HPRM: Bennetts Green - Update on Referrals - Response to Landscape Referral

Referral Response DEV – Landscape/Urban Streetscape

DA/251/2013/A

WINDALE NSW 2306, 20 PACIFIC HIGHWAY, BENNETTS GREEN NSW 2290

2 EAST ELEVATION (BUILDING MATERIAL & LANDSCAPING YARD)

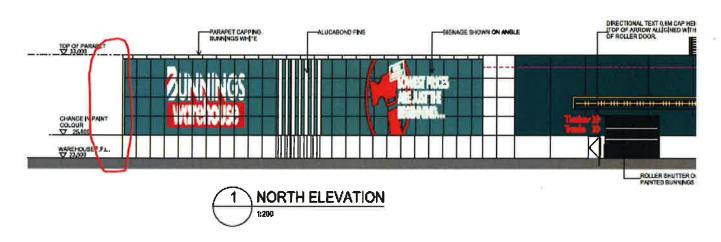
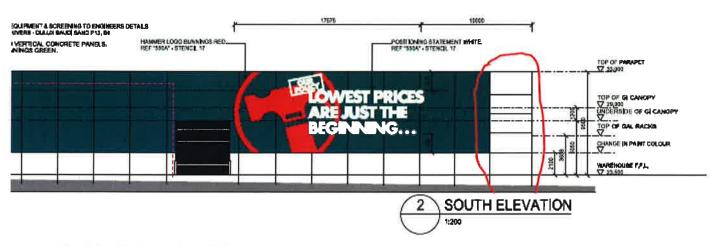
The architectural detailing to the corner of the Bunnings building when viewed from the Pacific Highway appear to differ from the agreed architectural design as outlined in Buchan Group BG-TBG-ZA-00-IM-ATP or D08887755. This design featured white corner panels wrapping both corners of the Pacific Highway elevation, fins the full height of the building roughly centred along Pacific Highway elevation and an extended roof that created a narrow shadow line. This render is the supported version.

• <u>Details on Bunnings building</u> – It is possible that there has been an interpretation issue with the elevations. The East Elevation and Perspective of the Bunnings building from the south correctly show white corner panels on the façade as previously agreed (extracts below). The North Elevation of the Bunnings building is easily misread because the south east corner of the building is splayed. This splay results in the final row of panels of the building, with the white corner panels, not being visible in the North Elevation (extract below). You can see the white corner panels in question are correctly shown and visible on the South Elevation (extract below). We trust this resolves this issue.
